Title: **ISA Turn-on Hangup**
Bulletin #: ISA0001 Issue Date: April 4, 2002
Models Affected: ISA 750, 800T, 450, & 500T
Bulletin Revision: A
Production Range: 01/2000–04/2002 (serial # 0100xxxxx–0402xxxxx)

Description

Figure 2. Prop the channel module assembly up on the chassis standoffs.

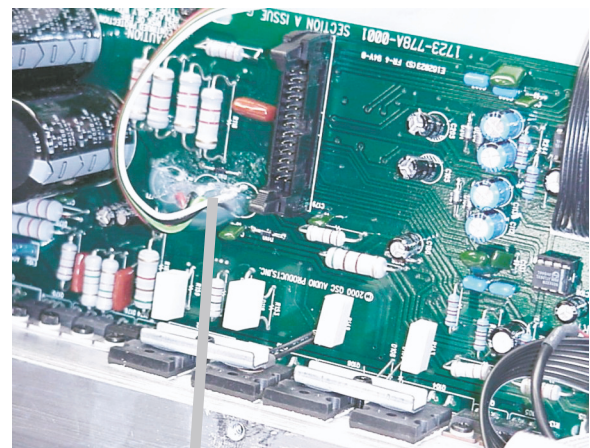
5. Lift up the front of the channel module assembly. Rotate it so that channel 1's module (the lower one) is on top; set the assembly down in the chassis with the heat sink resting on the standoffs (Figure 2).
